ADDENDUM NO. 1**BID CALL NO. T2024-036****REPLACEMENT OF COMPLETE POWER DISTRIBUTION, ASPHALT PAVEMENT, LIGHT
STANDARD AND ELEVATOR UPGRADE AT PROFESSOR'S LAKE RECREATION
CENTRE**

PROJECT NAME: Power distribution, Asphalt and light standard replacement

ADDENDUM NO.: #1

The following amendments are hereby made as part of the Contract Documents. The following revisions and/or additions shall be made to contract documents and the cost shall be included in the Tender Price.

ELECTRICAL DETAILS
PART 2

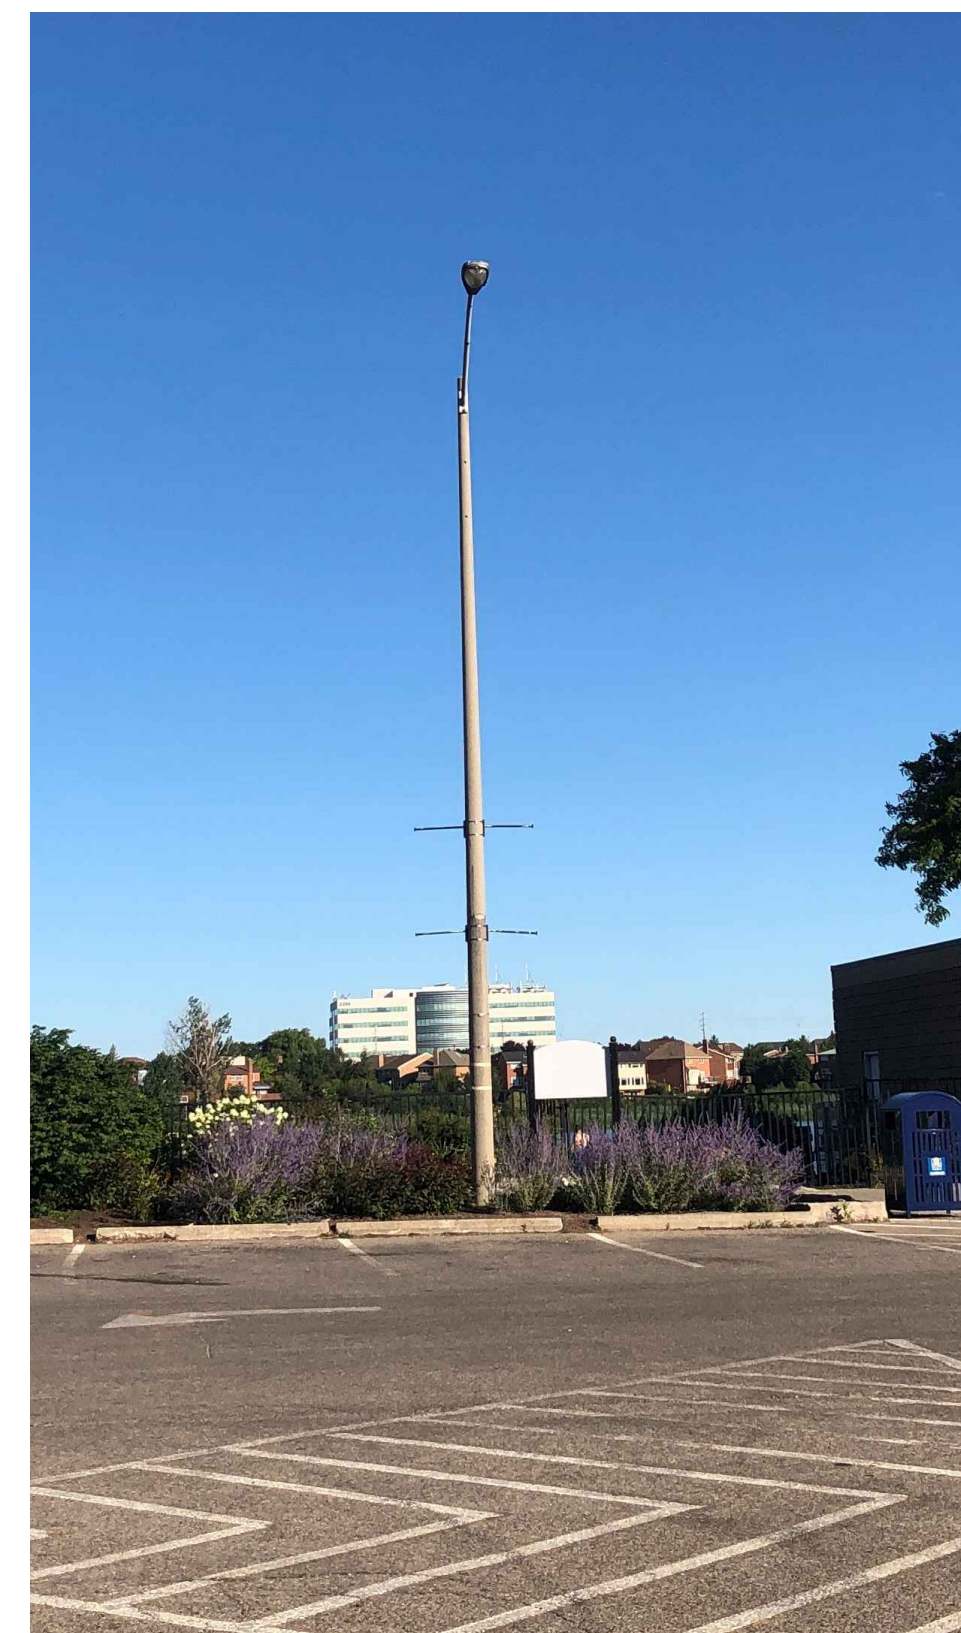
1.4 Refer to Drawings E200, E300, E301, E601

Review and follow the changes in the bubbled areas.
